N194NAS1

TECHNICAL BULLETIN

308-07B / 07C: Transfer Case

Service Action: Torsional Damper Bolt Incorrect Torque

E225516

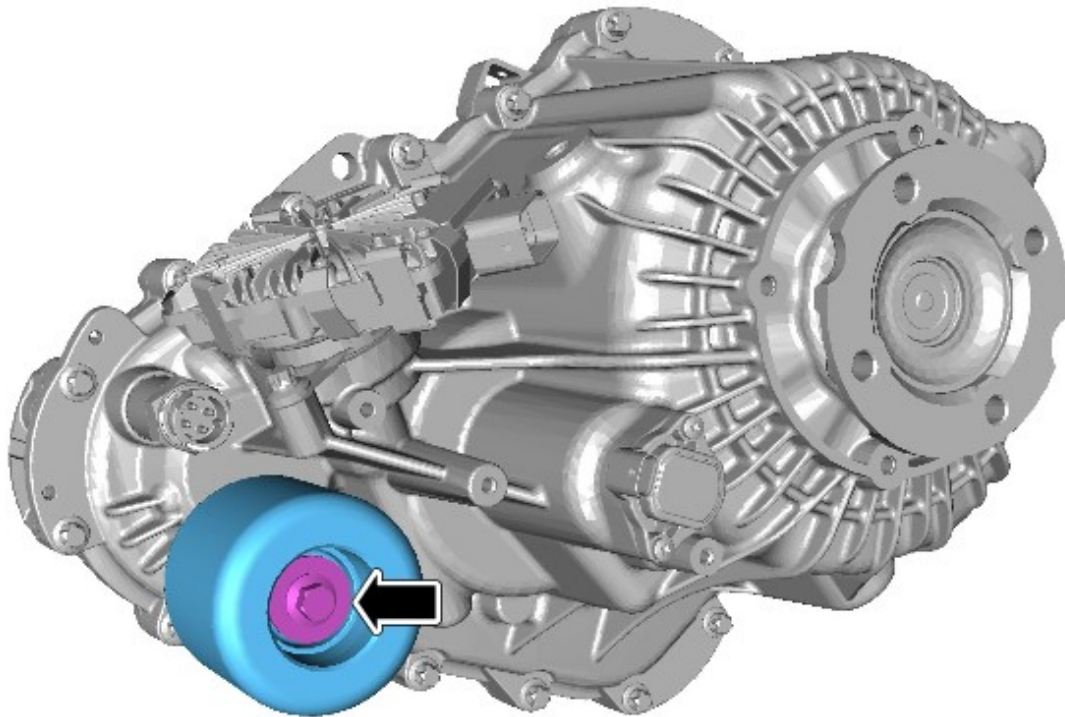
An issue has been identified on certain vehicles within the listed Affected Vehicle Range which have had a transfer case replacement and, as a result of an incorrect instruction in the Workshop Manual, may have had the incorrect torque applied to secure the torsional damper.

Tighten the transfer case damper retaining bolt.

- Torque: **75 Nm**
